**AMENDMENT Application to the  
North Dakota Public Service Commission for a  
Certificate of Site Compatibility  
Antelope Hills Wind Project  
Mercer County, North Dakota**

**Case #: PU-14-679**

**Antelope Hills Wind Project, LLC**

**July 22, 2015**

**FIGURE 1**

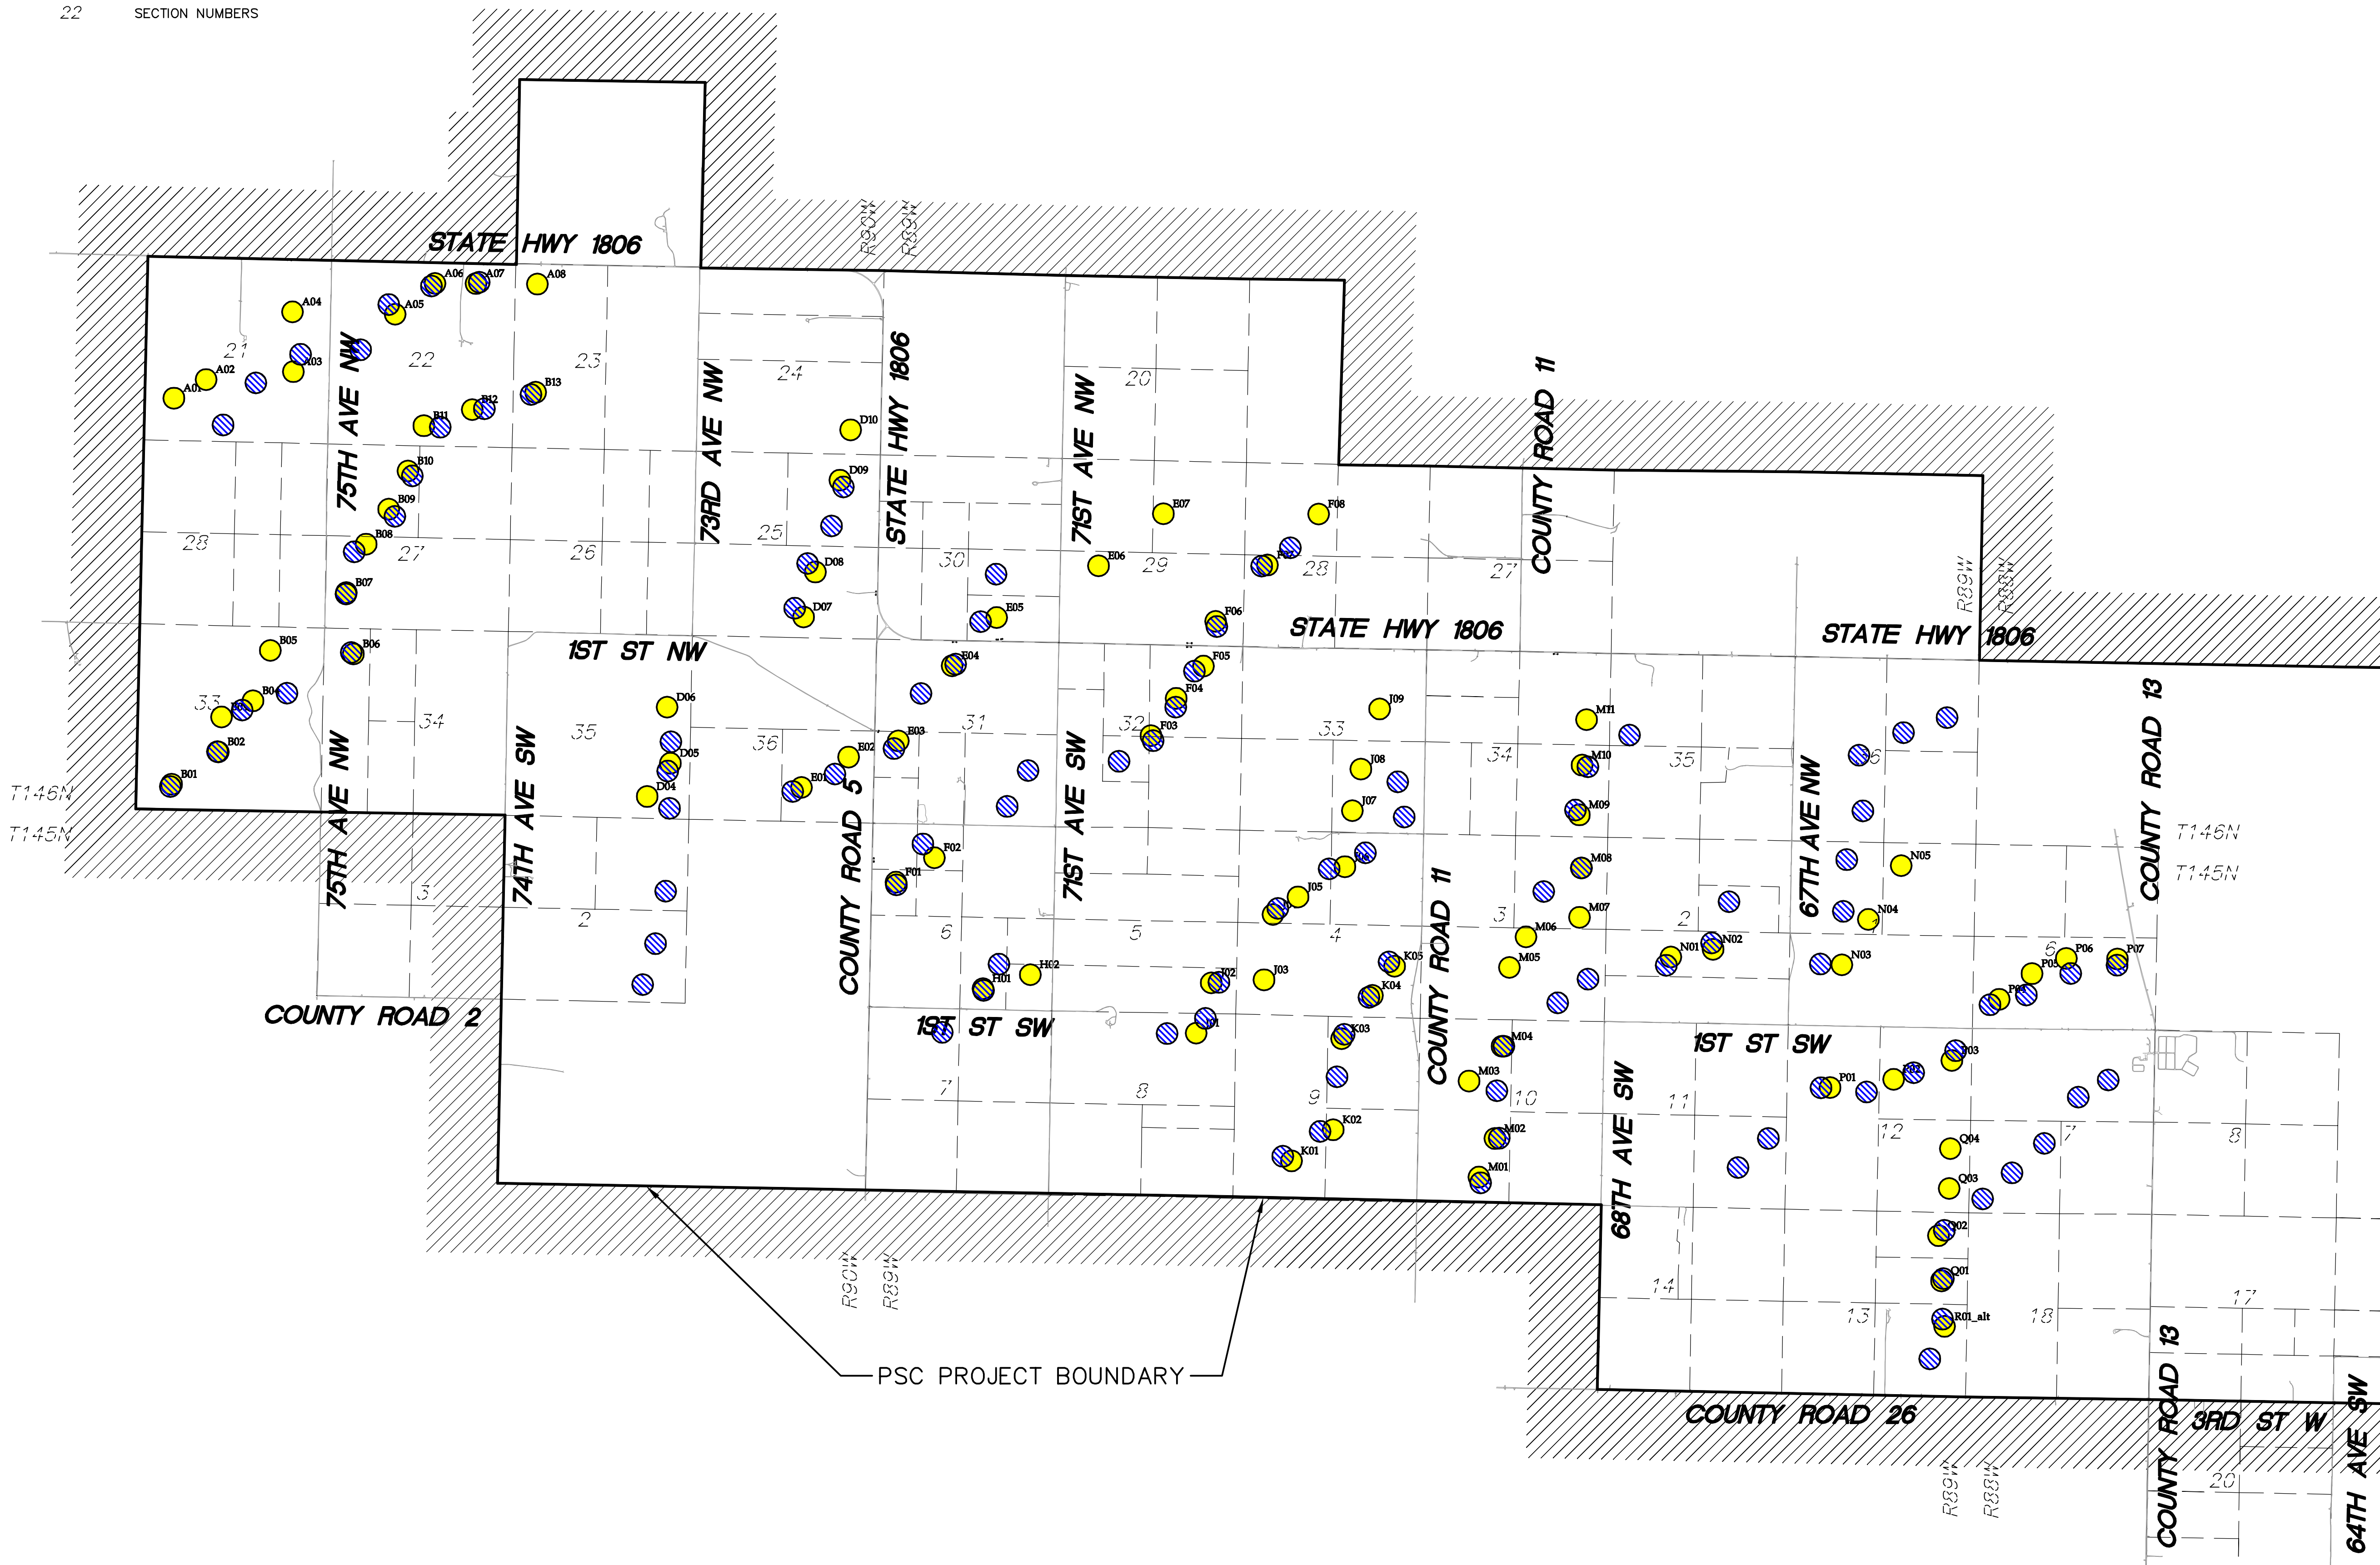
The PSC Certificate for the Project included preliminary (conceptual) design locations for the wind turbines. Based on site specific analyses (including geotechnical and detailed electrical and civil engineering studies, micro siting evaluations, and an effort to avoid and minimize potential impacts to wetlands), that will ensure compliance with the ND Energy Conversion Facility Siting Criteria (ND AC Section 69-06-08-01; the (“Siting Criteria”), Antelope Hills Wind Project, LLC (“Antelope”) has prepared a revised wind turbine layout for the Project. This revised layout (Figure 1 and 2) consists of a maximum of 87 wind turbines (either the Vestas V100-2.0 MW or the Vestas V110-2.0 MW turbines) in arrays that generally follow the arrays approved in the PSC-approved Certificate. The revised layout for the Vestas V100-2.0 MW turbine compared to the PSC-approved layout for the V100-2.0 MW turbine is illustrated on Figure 1. The revised layout for the Vestas V110-2.0 MW turbine compared to the PSC-approved layout for the V110-2.0 MW turbine is illustrated on Figure 2.

**Figure 3**  
**Feasible Turbine Placement Areas**  
**With Turbines**  
**Antelope Hills Project**

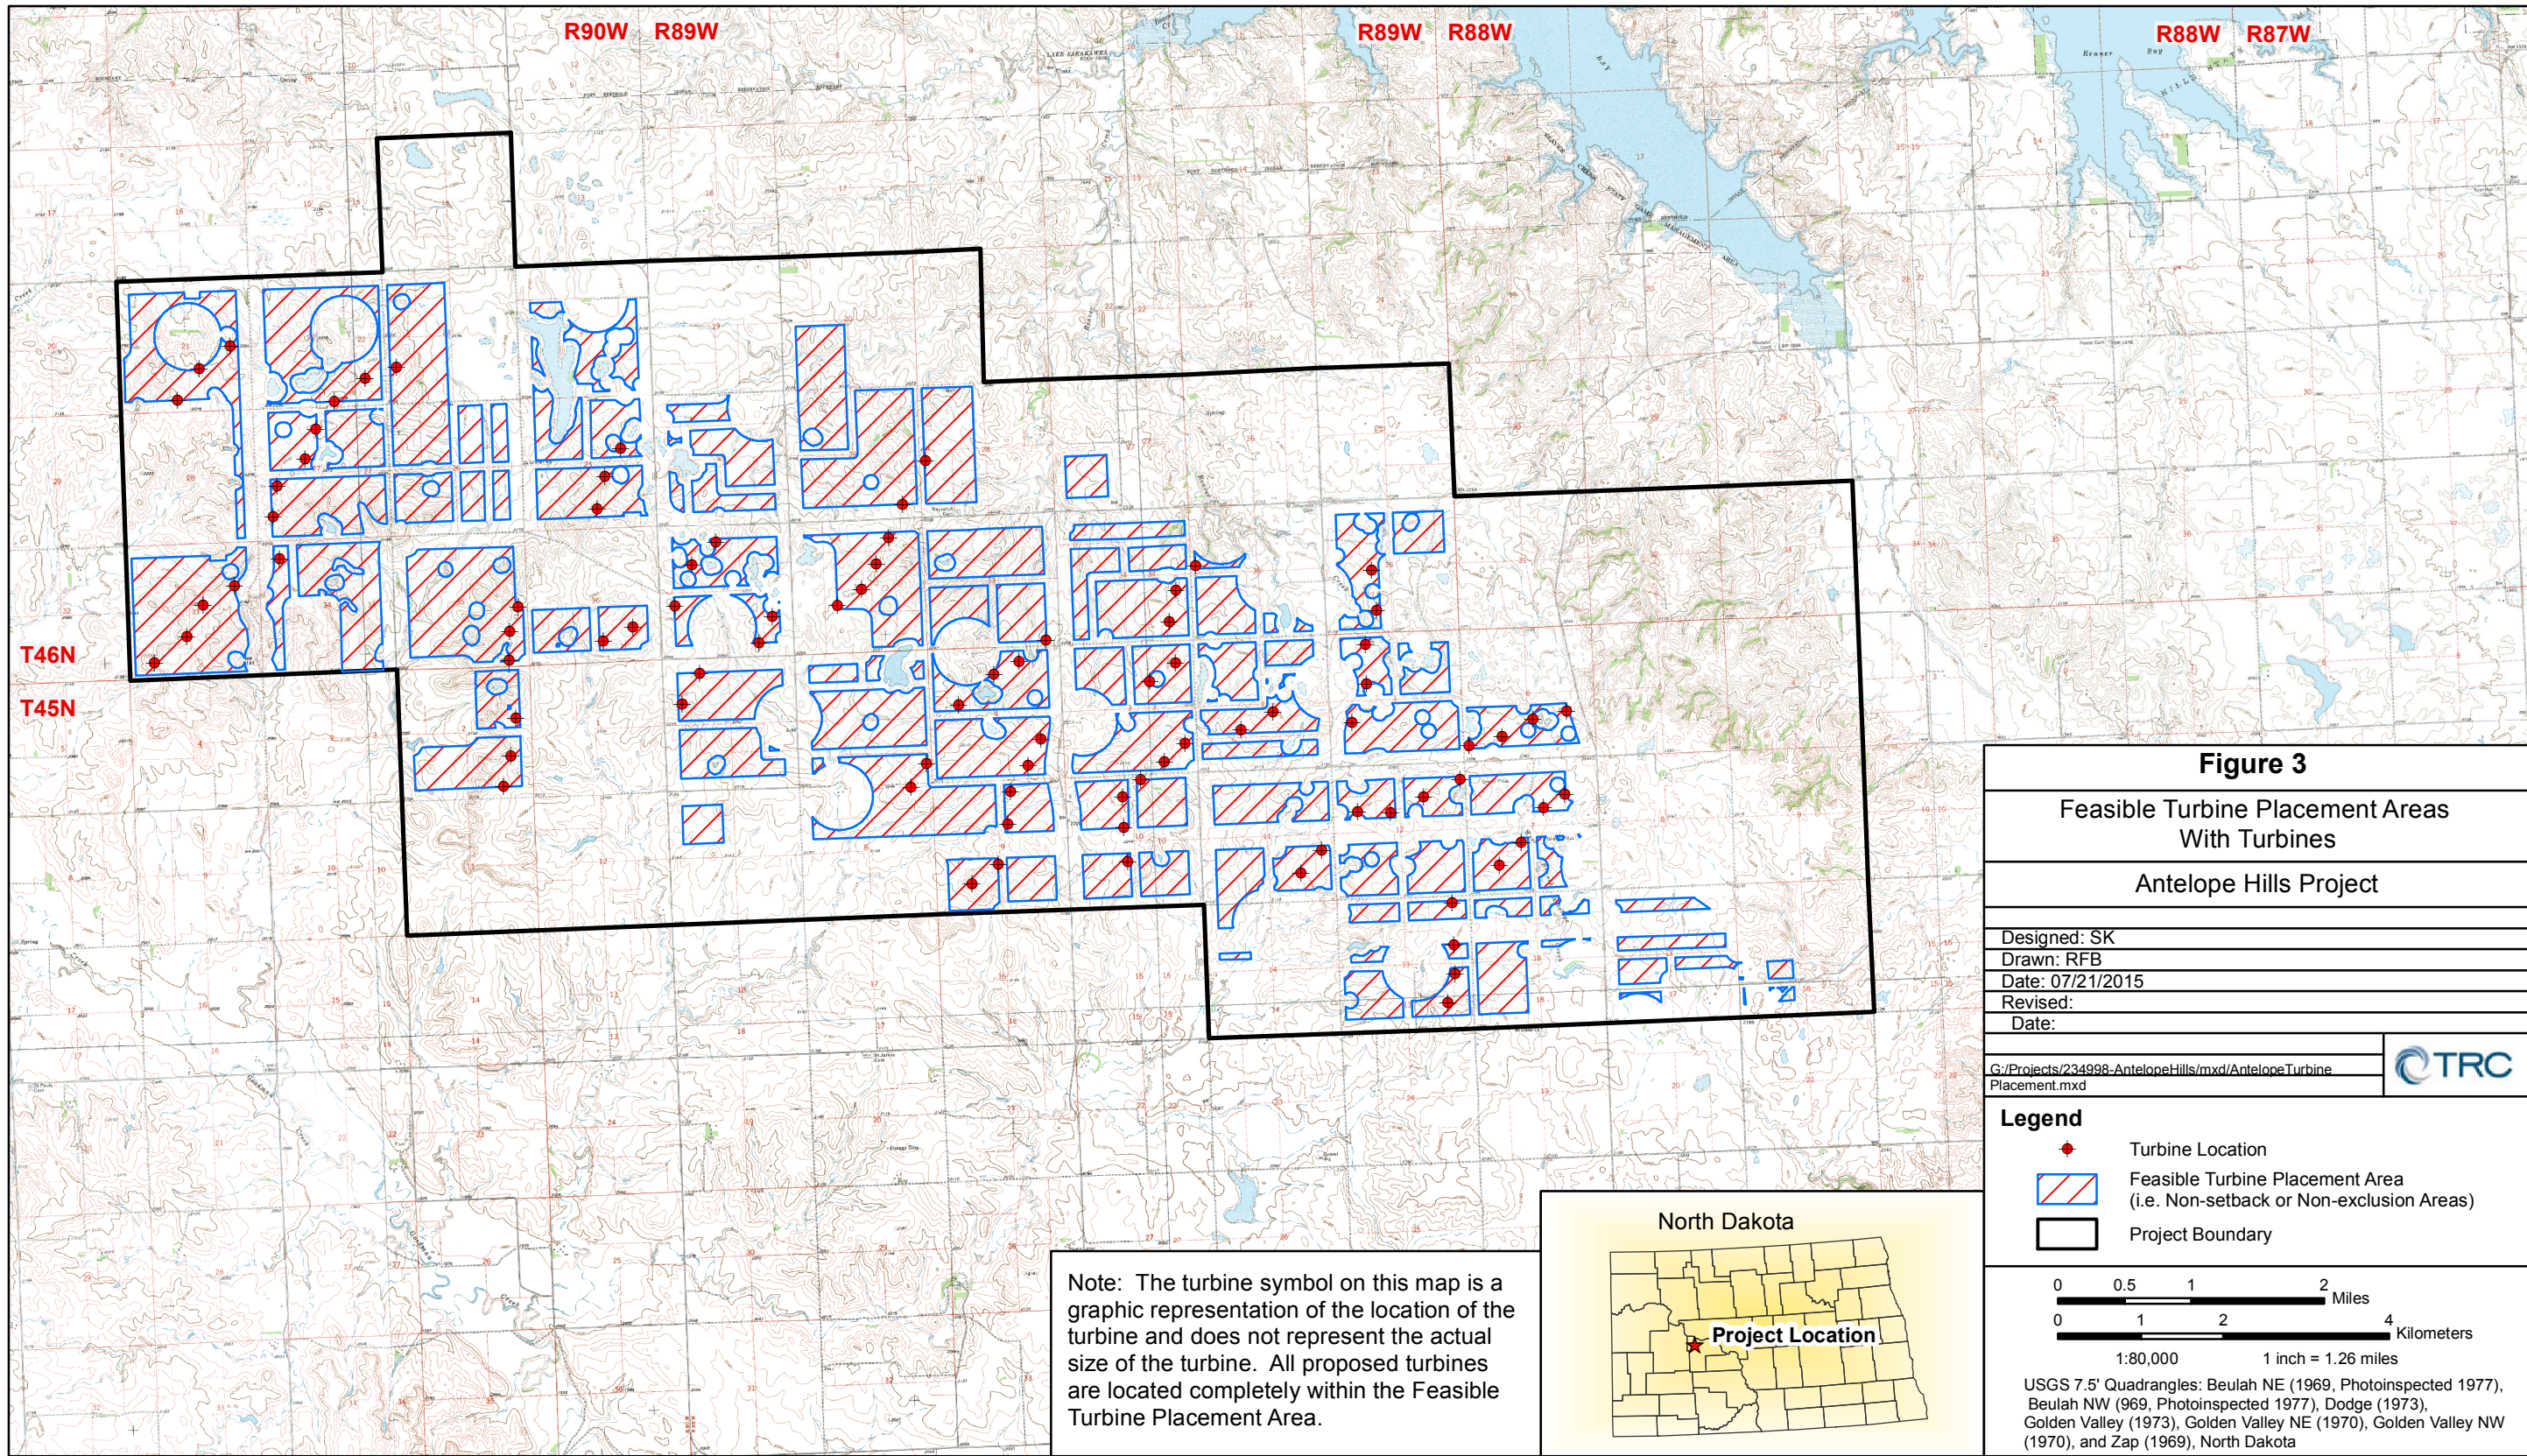
As illustrated in Figure 3, Antelope’s environmental consultant, TRC, created a map depicting the revised turbine layout’s compliance with the Siting Criteria’s avoidance and exclusion areas in the vicinity of the Project. In all cases where turbines have been relocated, Antelope has complied with all applicable setbacks from non-participating landowners. As a result all turbines have been located in the Feasible Turbine Placement Area (i.e., non-setback or non-exclusion areas).
